Terminal Tractor Service Bulletin

Subject: Ottawa T2 Motor Mounts			
Product: Medium Terminal Tractor	Bulletin # SB16TI0060	Date: 8-August-2016	Pages: Page 1 of 2
To: All Kalmar Sales Companies		From: Medium Terminal Tractor Product Support

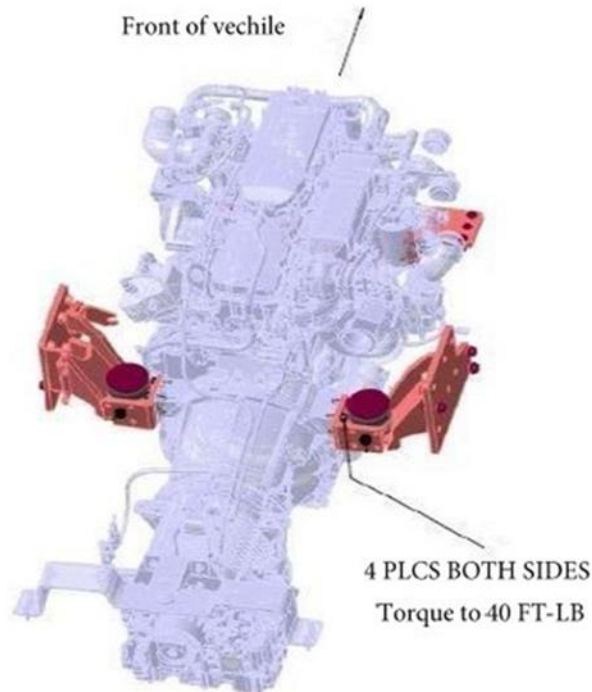
1. The locking tab for the front motor mount may not be properly engaged with the slot in the motor mount. If not properly engaged the front motor mount attaching hardware can loosen.
2. The hardware attaching the rear motor mount to the flywheel housing can loosen during operation. If the truck is operated with these bolts loose it can result in damage to the flywheel housing and / or the motor mount.

Solution: The front and rear mounts should always be inspected as part of normal preventative maintenance. Incorrectly installed front mount locking tabs should be reused and installed correctly. Loose rear mount attaching hardware at the flywheel housing should be removed and reinstalled using blue Loctite and torqued to 40 ft-lbs.
